Project: LPS Project D
Bid Package #7636-D

Project No.: 14-022

Addendum No.: 1

CHANGES TO PROJECT MANUAL

Detail 10 – AV Gearbox

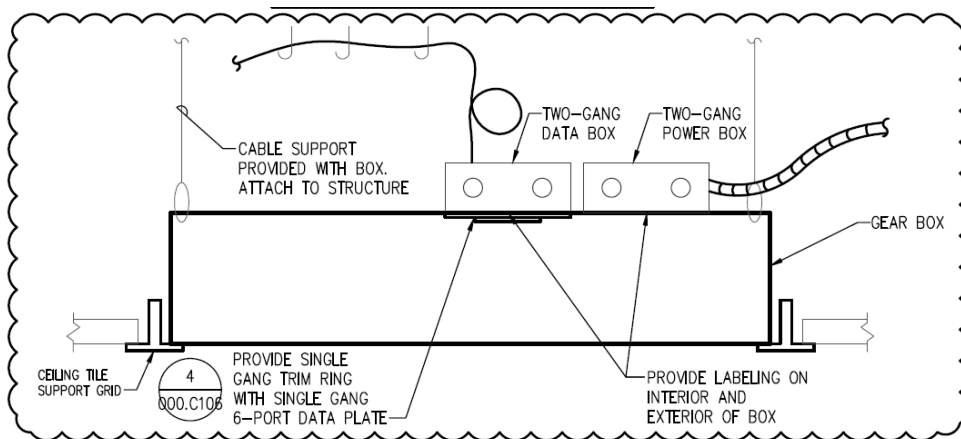
1. Clarification: detail indicates to provide labeling on interior and exterior of box for Data j-box and Receptacle J-box. Contractor shall also provide labeling at exterior of Gearbox to indicate closet, rack, patch panel, jack #, etc. for data cabling and also panel & circuit info of receptacles. These labels shall be clearly visible at the exterior underside of the Gearbox.
2. See below for revised AV Gearbox detail with changes clouded.

SHEET:
124.T02.A
 DRAWING #:
 AD01.124.T02.A-1

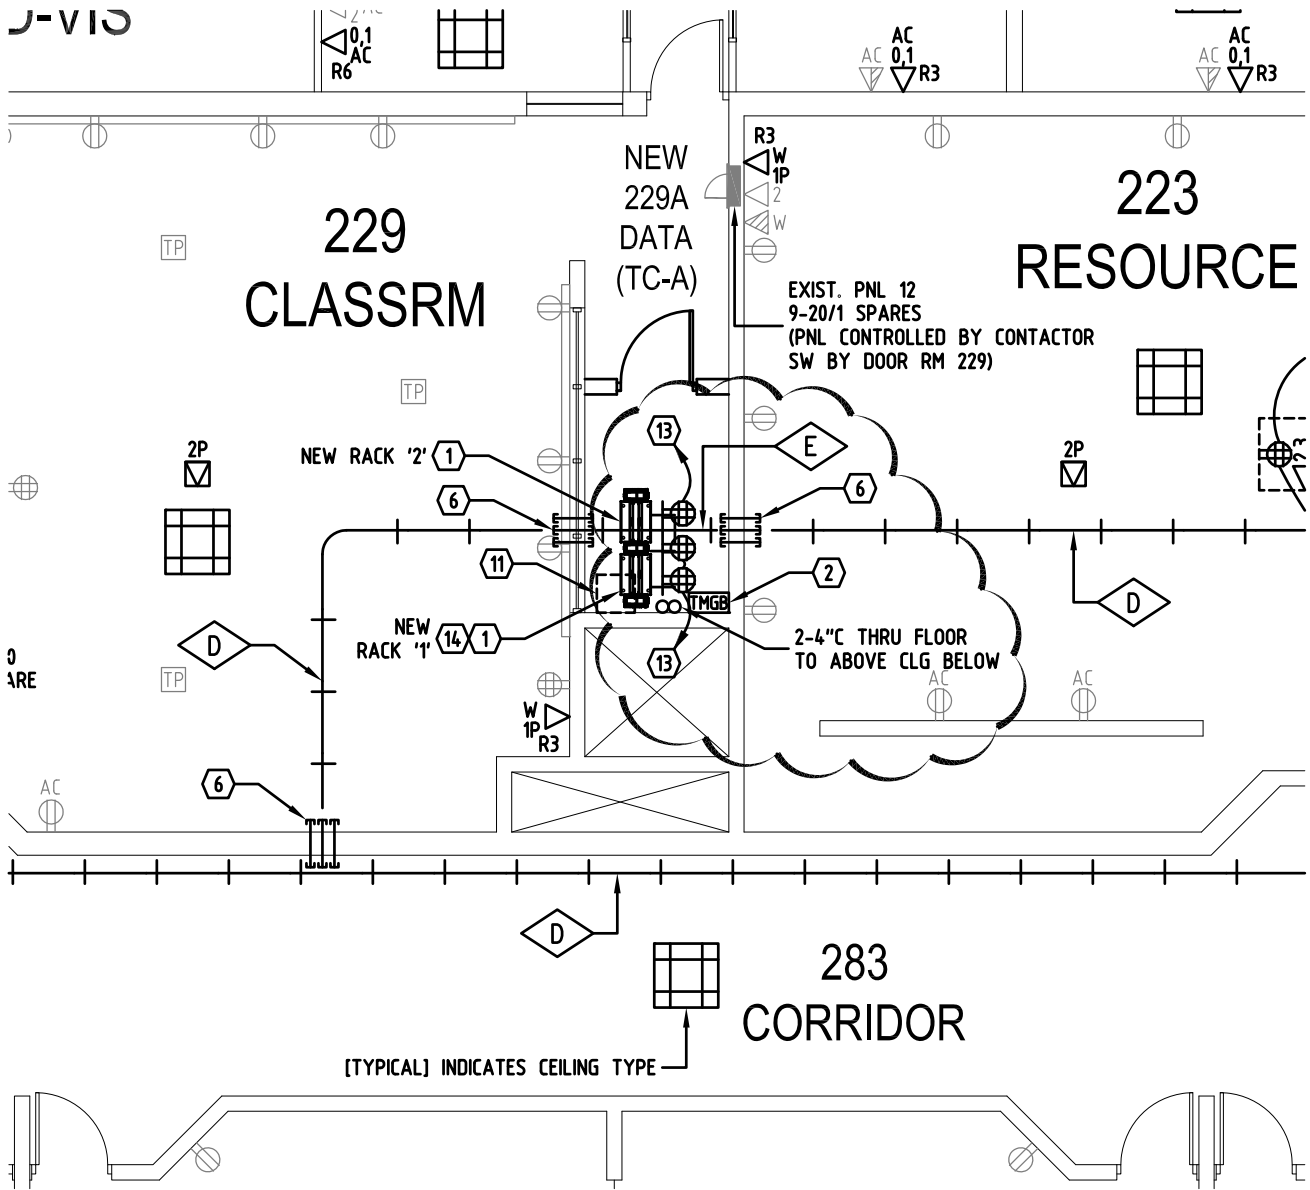
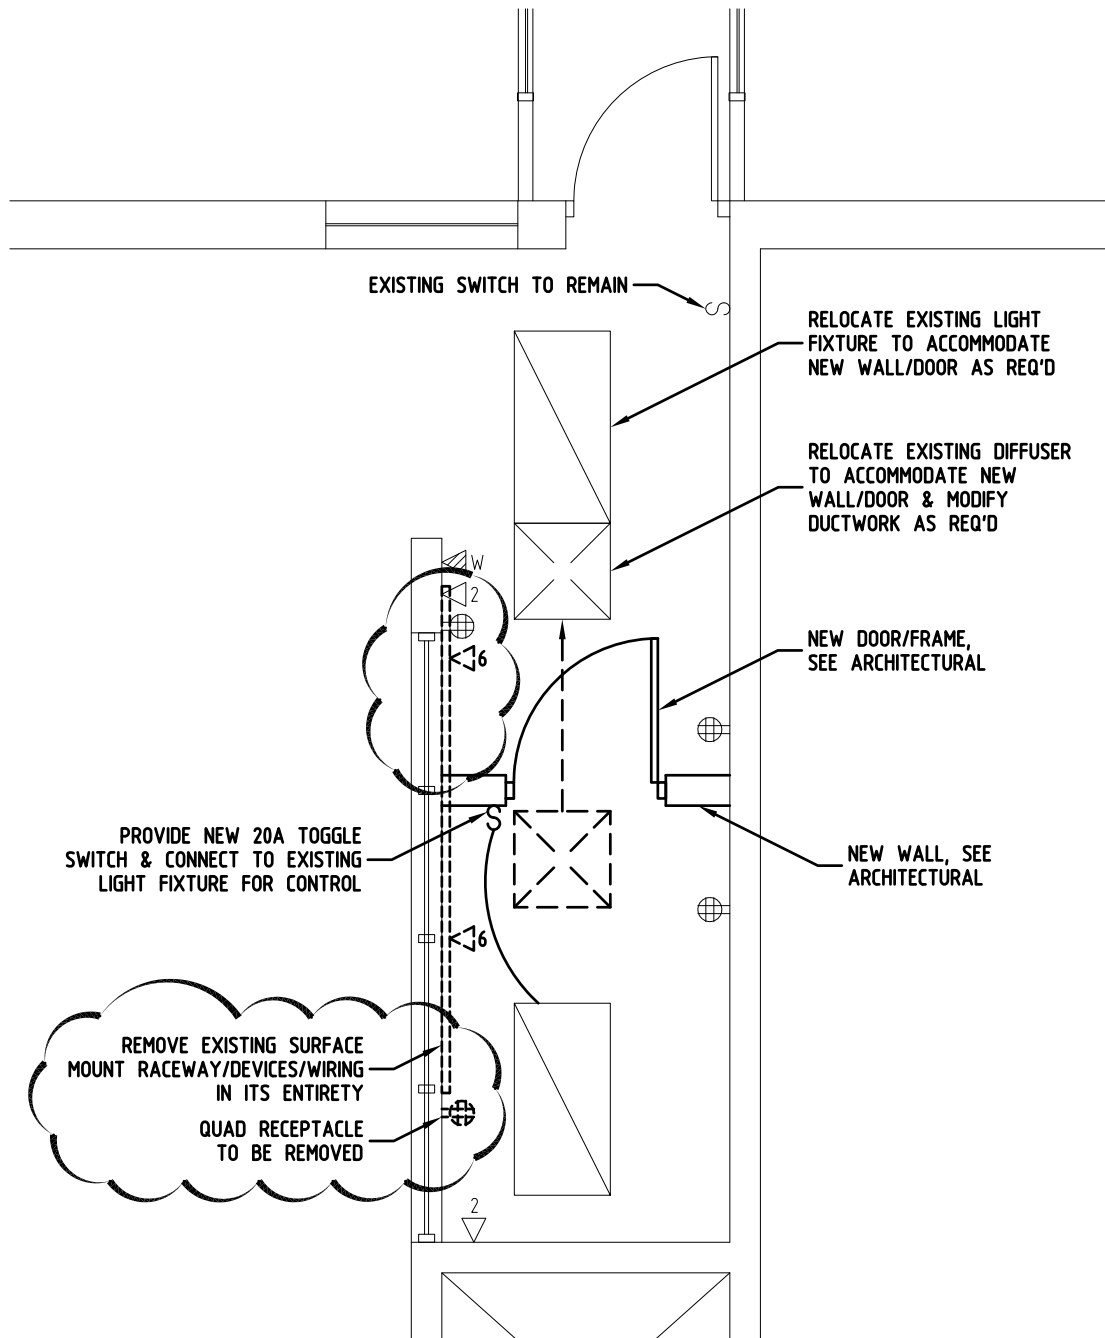
3. Delete (1) quad receptacle at racks in Data 229A (TC-A). Provide cable tray tee & install the (3) remaining quad receptacles as detailed in rack elevations on sheet 000.C102, see attached drawing AD01.124.T02.A-1.
4. Relocate floor penetrations in Data 229A (TC-A) to west wall, see attached drawing AD01.124.T02.A-1.

SHEET: **140.T01.A**
DRAWING #: AD01.140.T01.A-1

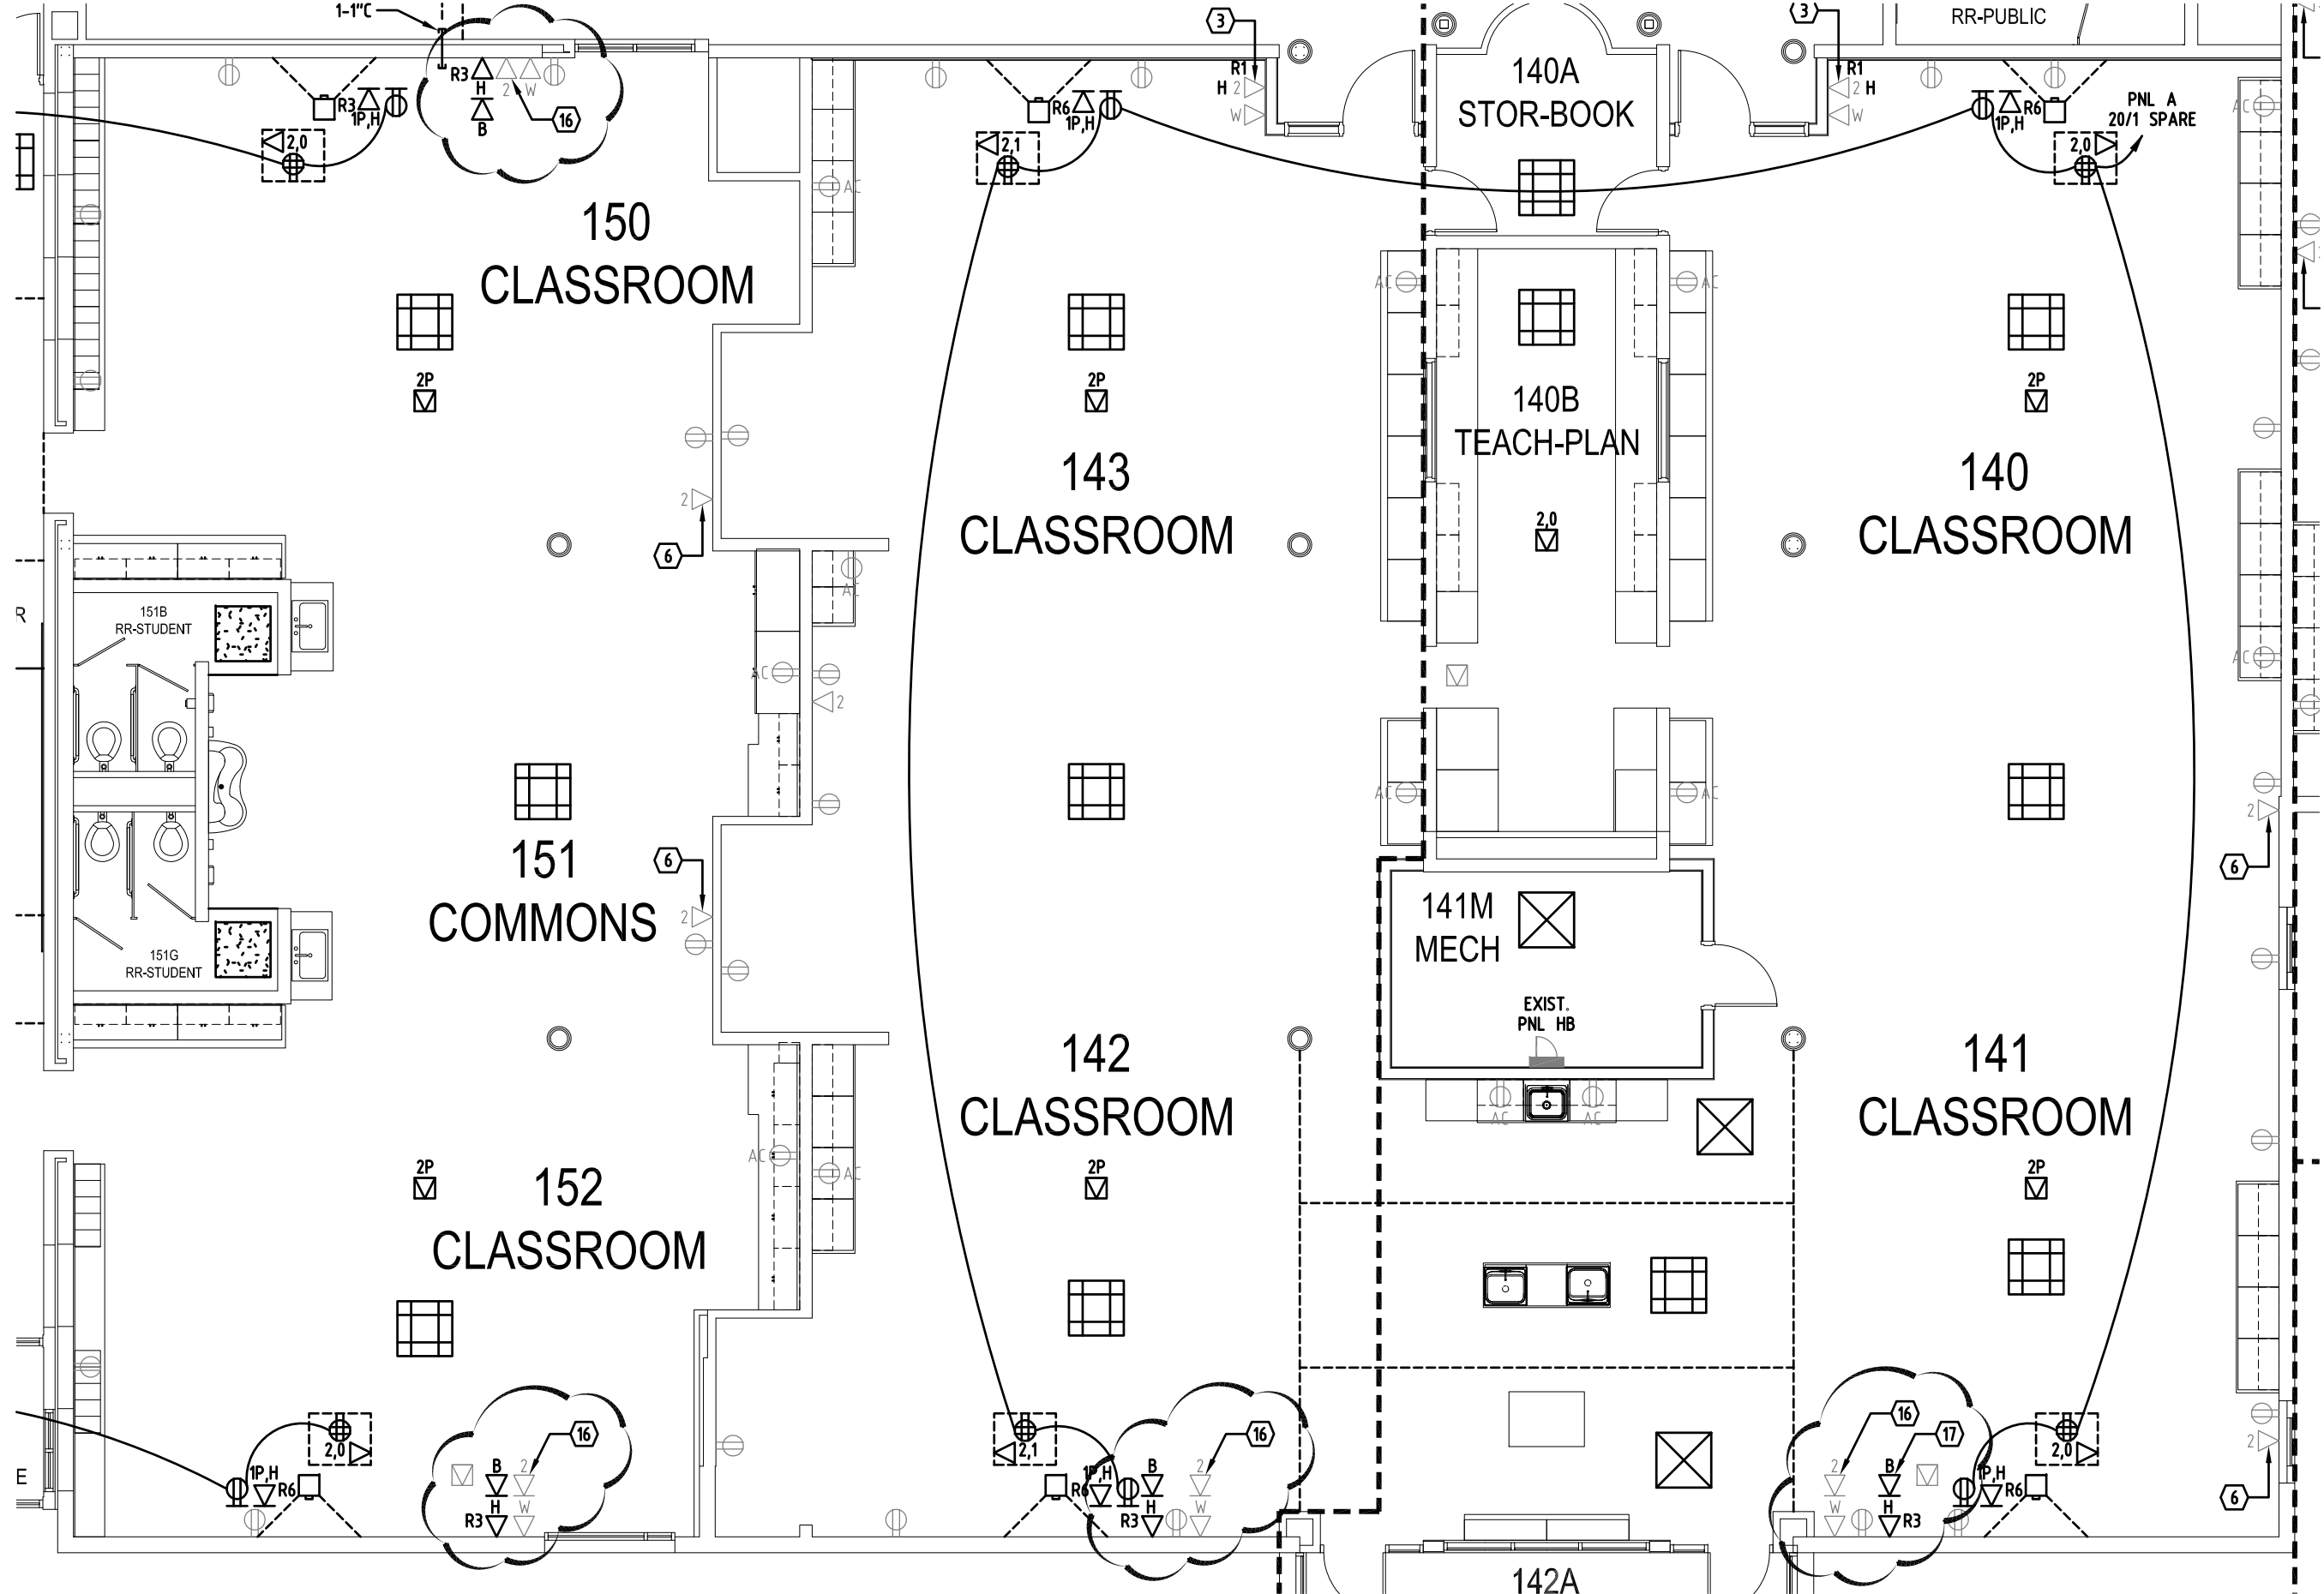
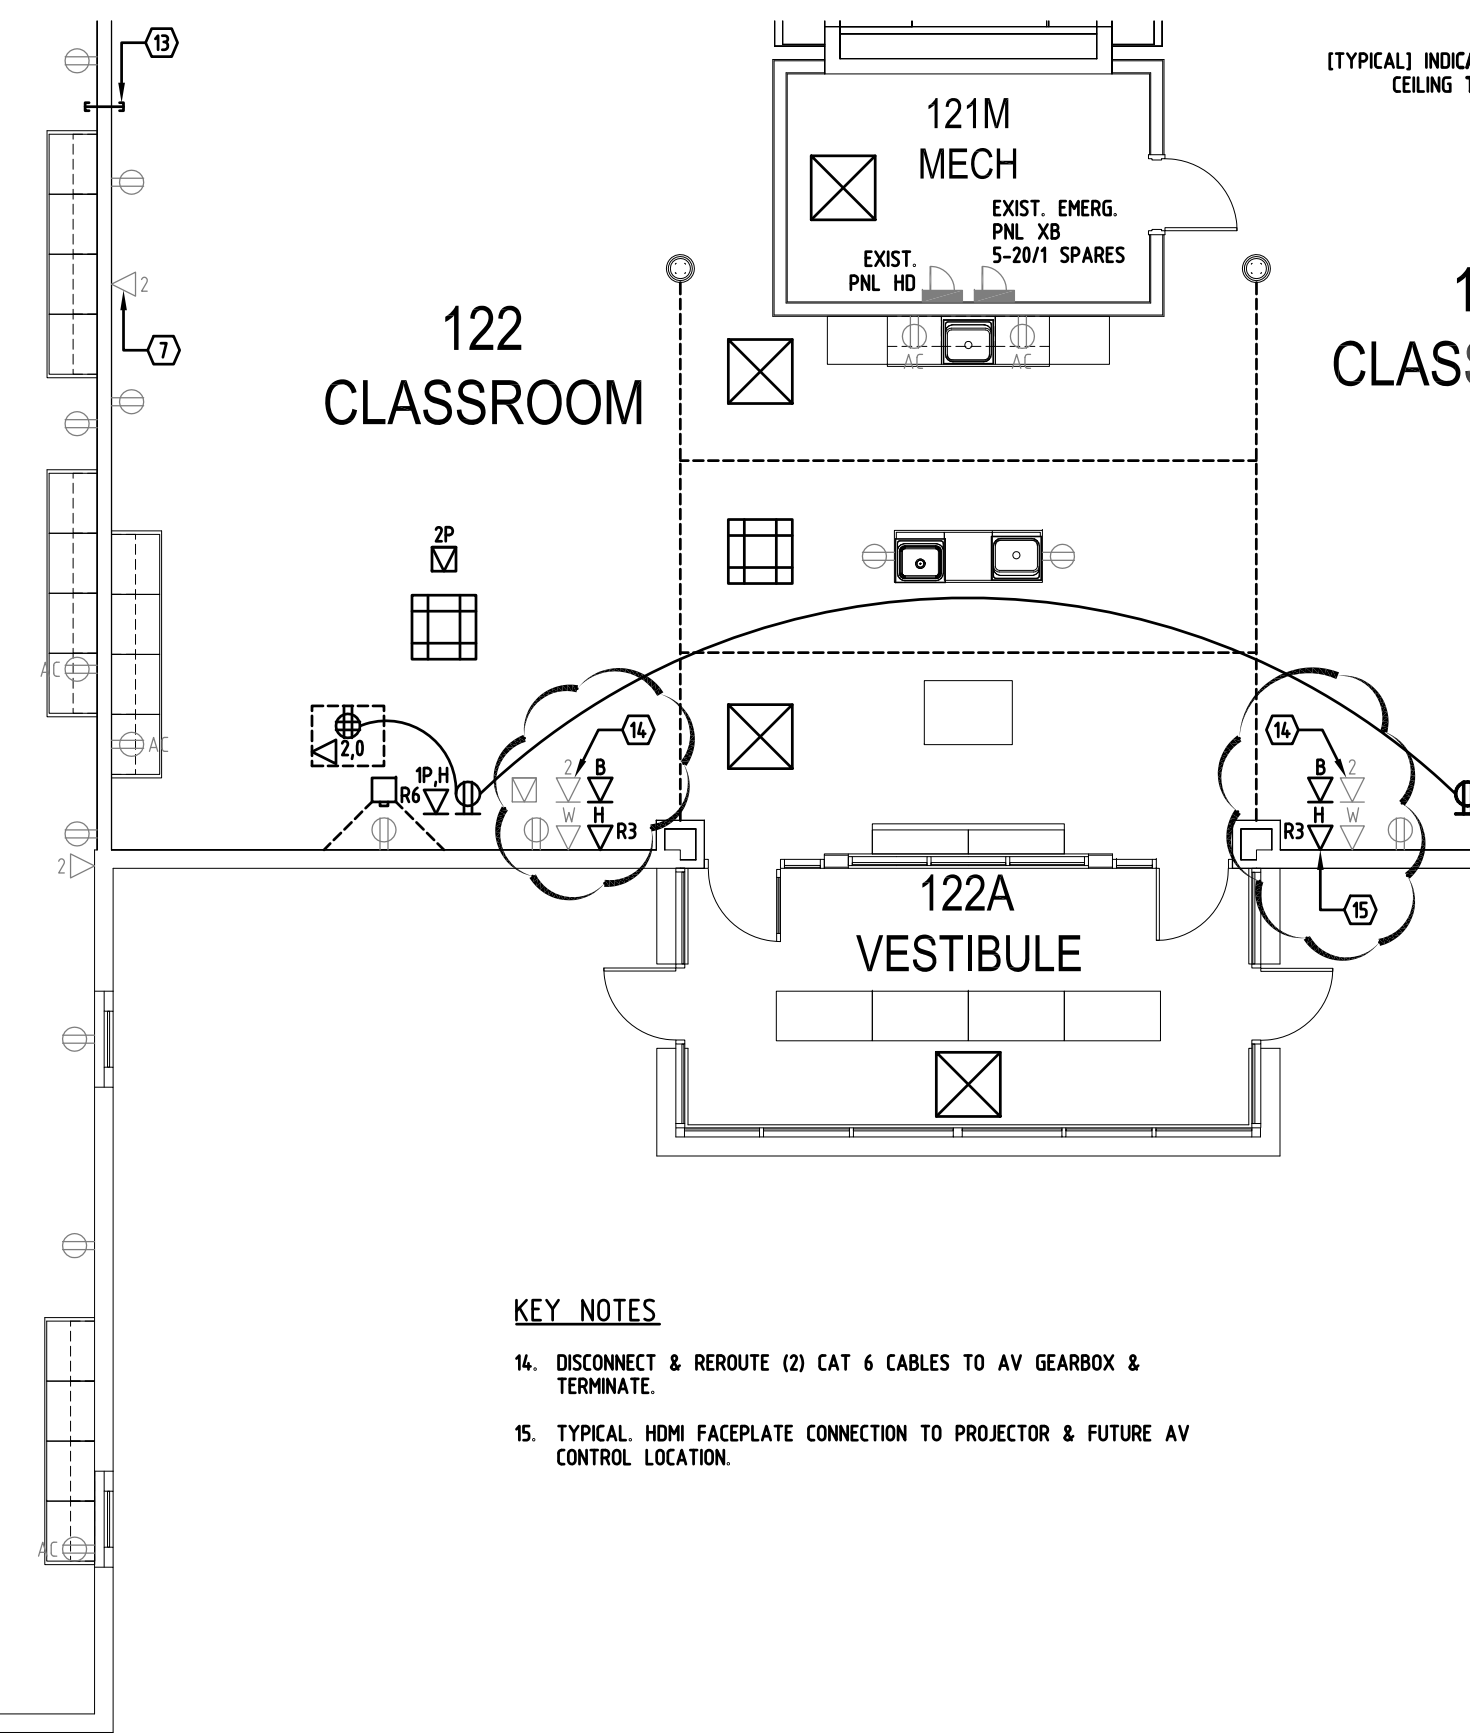
1. Classrooms 141/142/152/153: see attached drawing AD01.140.T01.A-1 with revisions for HDMI projection wall connections. Install new surface mount raceway and boxes for HDMI cabling as indicated. Delete keynote 3 and see new keynotes 16 & 17.

16. DISCONNECT & REROUTE (2) CAT 6 CABLES TO AV GEARBOX & TERMINATE.
17. TYPICAL HDMI FACEPLATE CONNECTION TO PROJECTOR & FUTURE AV CONTROL LOCATION.
